Official Transcript of Proceedings

Title: 650th Meeting of Advisory Committee on
Reactor Safeguards

Date: February 8, 2018

NuScale Design Certification Application Request
for Exemption from General Design Criteria 27

Simplified CVCS Diagram

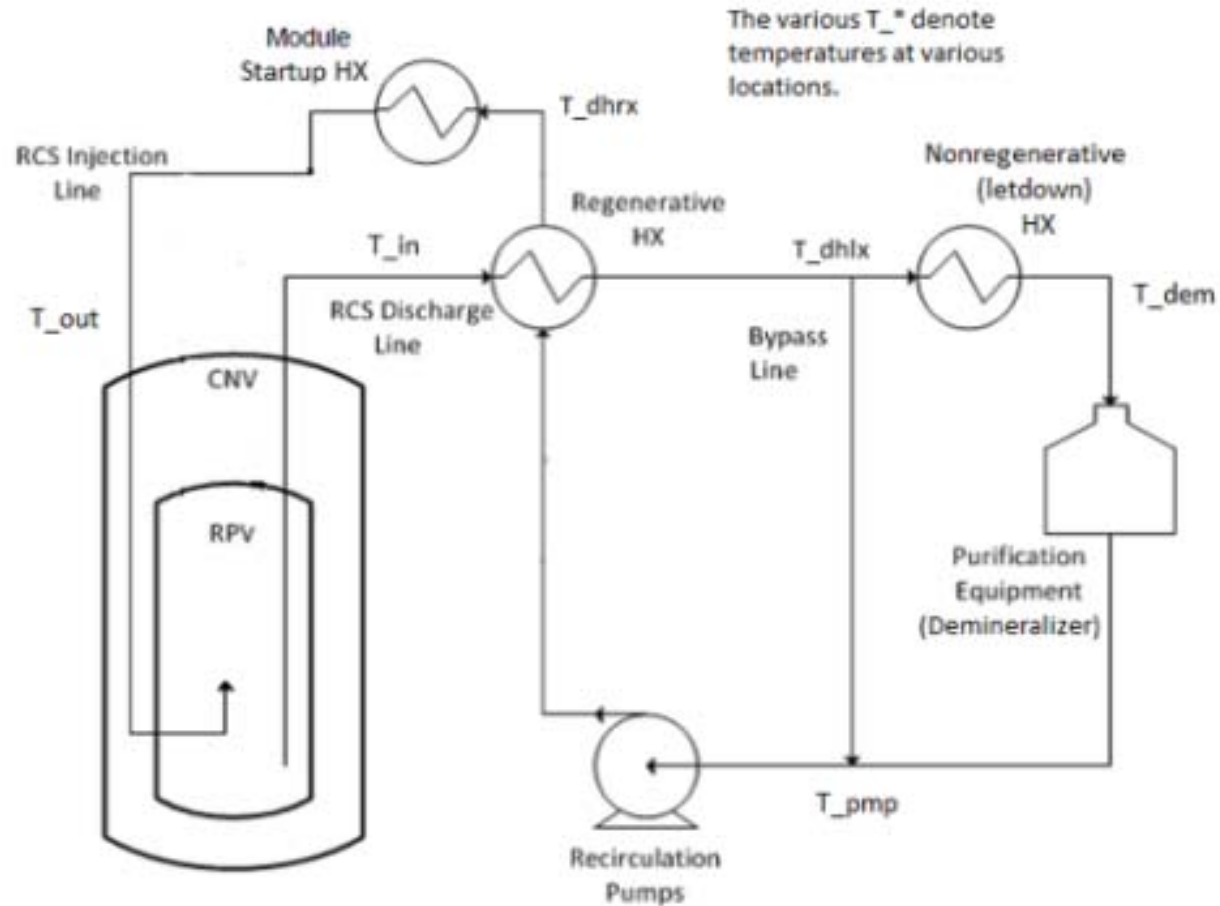
2 MEMBER MARCH-LEUBA: Before we run out of
3 time and they don't let me ask you a question, can you
4 go forward to slide 12, one of the backup slides?
5 Because I know I'm being polite, I kept quiet and then
6 when I ask a question, he doesn't let me ask it.

9 So, the CVCS injects into the vessel,
10 correct?

1 comment I made, I'll be curious for the analysis that
2 shows your capability to use CVCS to raise boron
3 concentration to that level that provides the hold
4 down that compensates for the stuck rod.

13 MR. BOTHA: Yes, and I think the short
14 answer for today is, it's long, but it's small in
15 comparison to the time you have before you get to
16 return to power condition.
